### List of Attachments to Siting Board and BBC Consultants Request for Information

## CASE NO. 2020-00272 FLAT RUN SOLAR, LLC RESPONSES TO SITING BOARD'S FIRST REQUEST FOR INFORMATION

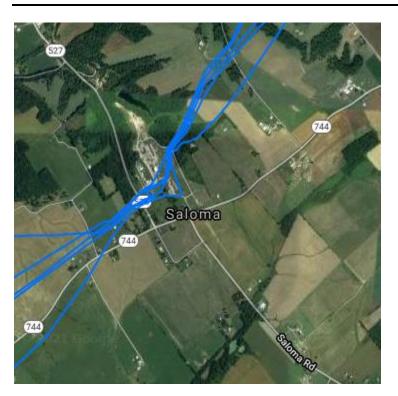
11. Refer to the Application, Attachment I "Map showing New Parcel" issued March 9, 2021. The northern part of this parcel, leased from Tennessee Gas Pipeline Company, is not a Potential Array Area. In the Application, Attachment K "Letter from Tennessee Gas" a letter from Carolina Solar Energy dated February 18, 2021, to Tennessee Gas includes a map which shows the solar arrays excluded from the northern part of the parcel. According to the National Pipeline Mapping System (<u>https://www.npms.phmsa.dot.gov/</u>), there is a Tennessee Gas transmission pipeline (100-2) that goes through the northern part of the parcel. Now refer to the Site Assessment Report, Attachment A "Preliminary Project Layout" dated March 15, 2021. The fence and the fenced area with the solar arrays appears to exclude the northern areawith the active pipeline.

a. Explain why the site plan shows the Potential Project Footprint Area extending to the northern edge of the new parcel.

b. Revise the Preliminary Site Plan to show the utility easement for the Tennessee Gas Pipeline and any adjustments that should be made to the Potential Project Footprint Area.

a. Please see Attachment G for an updated site plan that removes the mentioned area of the Potential Project Footprint.

b. Please see image below from the National Pipeline Mapping System which shows the location of the pipeline, which is now outside of the Potential Project Footprint area.
